REMARKS

In the Office Action, Applicant's election of Group I was acknowledged, and claims 17-24 were withdrawn from consideration.

FIG. 4

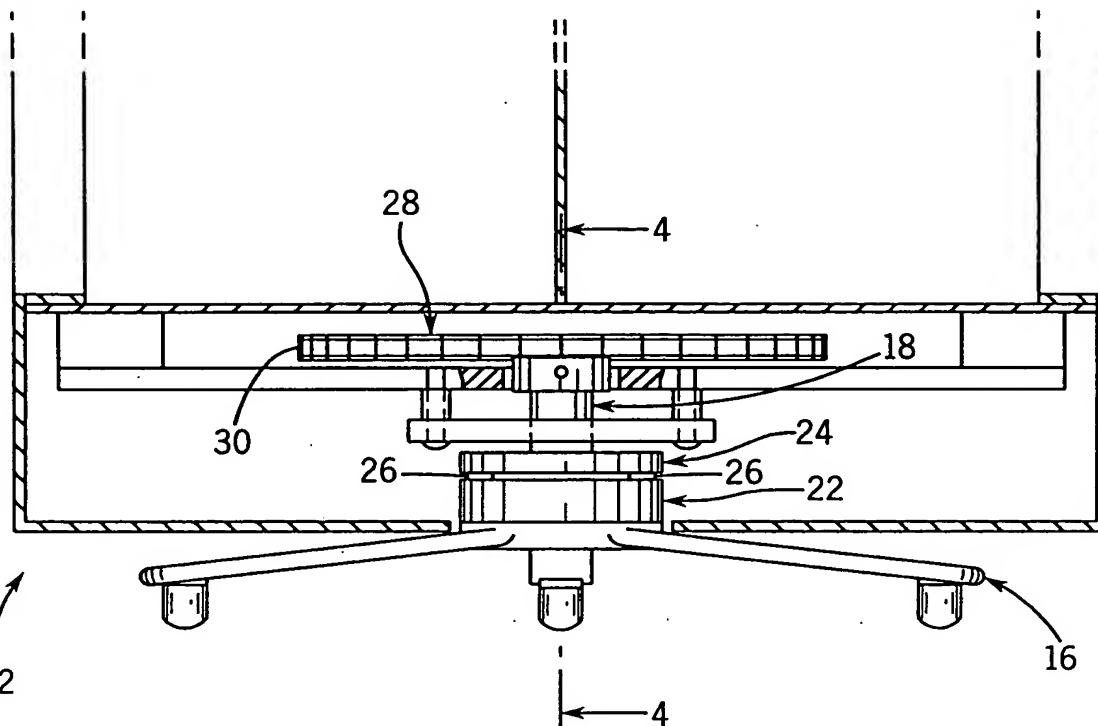
The drawings have been amended herein to add reference numeral 61 for passage in Fig. 4, as this reference numeral was missing from the drawings.

Reference numeral 61 added
